HISTORIC PRESERVATION ADVISORY COMMITTEE
MEETING
(Action) Meeting Minutes
December 7, 2022

PLANNING ACTION: PA-T1-2022-00199

SUBJECT PROPERTY: 748 Siskiyou Blvd

Comments from Dale Shostrom

Paddington - 1 - 001 - W1 (1 Thus)
 Frame: (BRONZE) T500 2-1/4 x7 OPG1900 SSG Vert

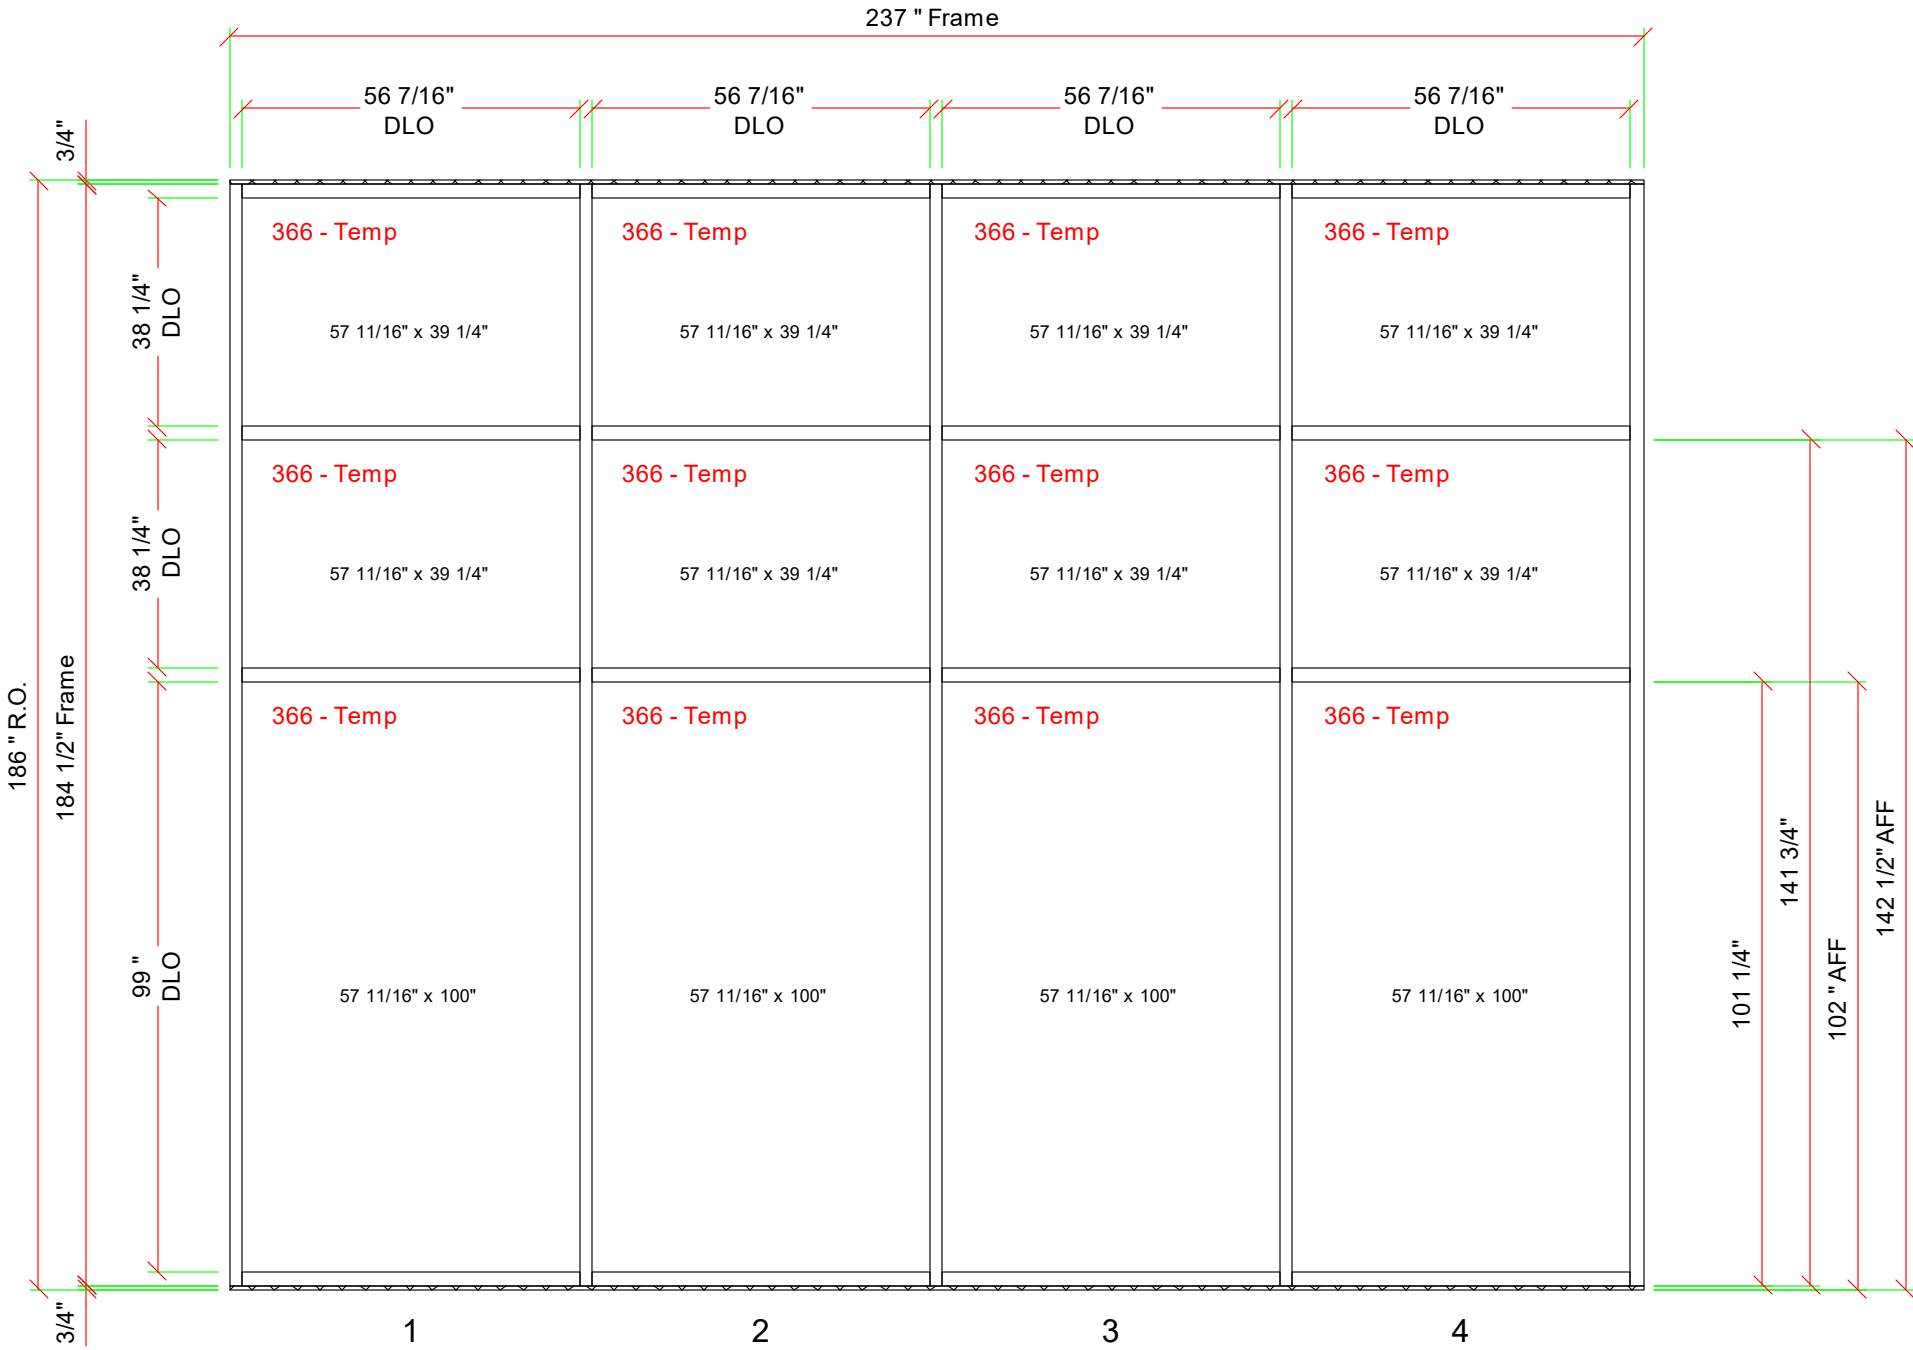
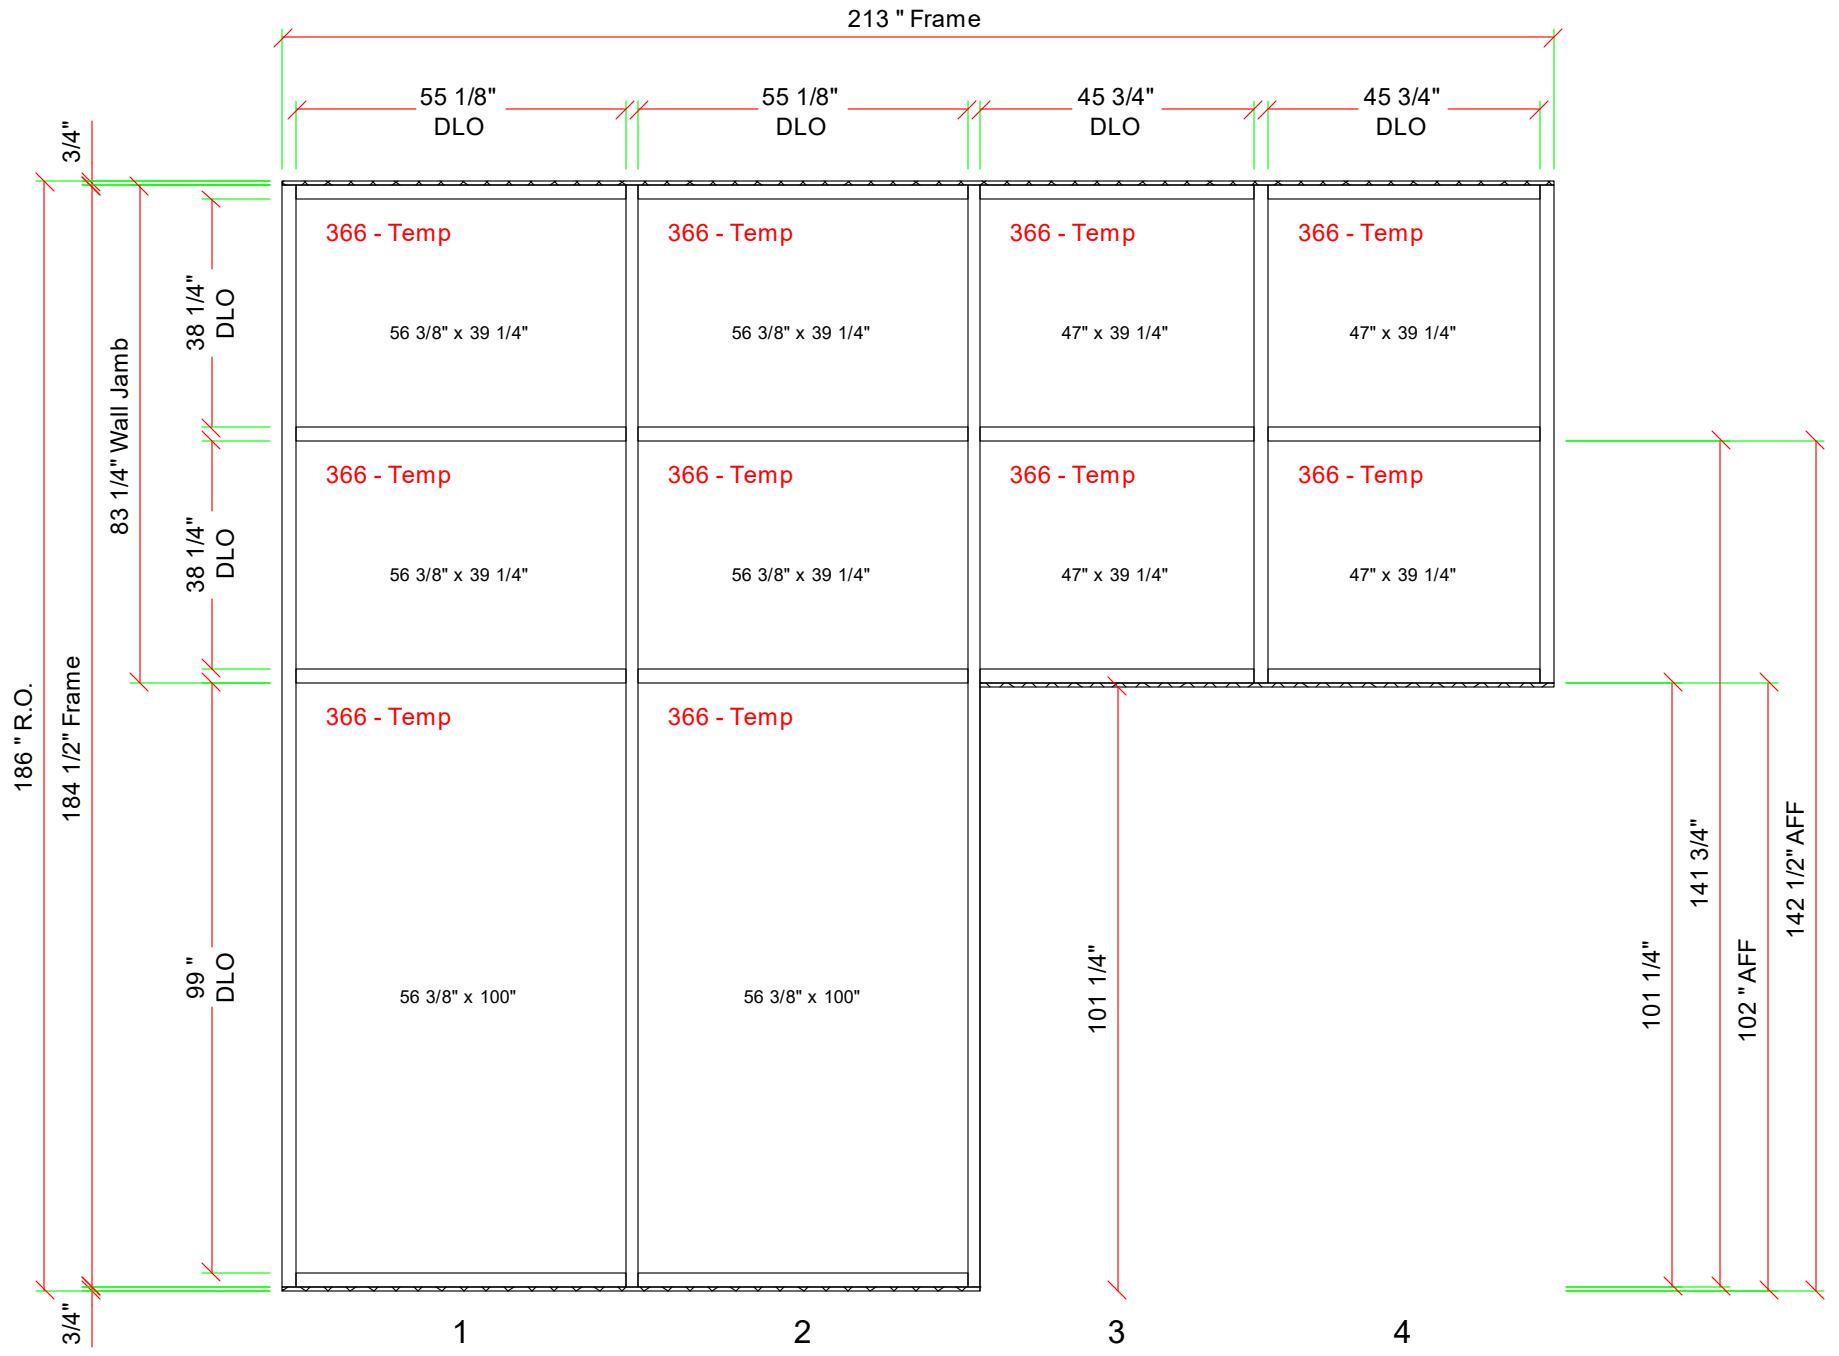
Last week I met at Paddington Station with Kyle Taylor, Taylor Elements Construction, to discuss the details of the owners' proposal for a total replacement of the two-story historic storefront display windows at the street entrance. Kyle explained that the owners were concerned about energy heat loss from the existing single pane glass, and if replaced, would also add a safety factor with the addition of tempered glass.

The proposal for the window replacement would affectively remove all the historic window glazing, the wood sash support, and the original half-round sheet metal cladding and trim. The two-story high glazing area is approx. 15 ft. high and 36 ft. wide except for the recessed double entry doors. Additionally, the proposal calls for reducing the three, 10 ft. wide display picture windows, into six, 5 ft. wide display windows.

Historically, storefront display windows were kept as wide as possible to provide the best visibility for the merchandise and is a common pattern found in the downtown. The storefront windows in the Paddington Station building are particularly notable because they are the largest original storefront windows in our Downtown Historic District.

Replacing all the components in a glazing system with new material that will noticeably change the historic appearance is not recommended.

Changing the appearance of windows and window features by replacing the materials, finishes, or colors which noticeably change the sash, depth of the reveal, muntin configurations diminish the overall character of a historic building. For this reason, the removal or replacement of the windows is not recommended.

If this project were a Planning Action (and it is not), the Historic Commissions requirements would include detail scaled drawings at $1\frac{1}{2}'' = 1 \text{ ft.}$ to ensure compatibility with the remaining historic components. Those would include detailed sections of the window sills, all jamb conditions, heads, and trim. Additionally, I would suggest that all the new materials including the aluminum and wood parts be painted to match as is the case now, which would hide and mitigate the impact of these modern aluminum materials.

Committee was unanimous in their decision that the applicant should come back with a formal application.
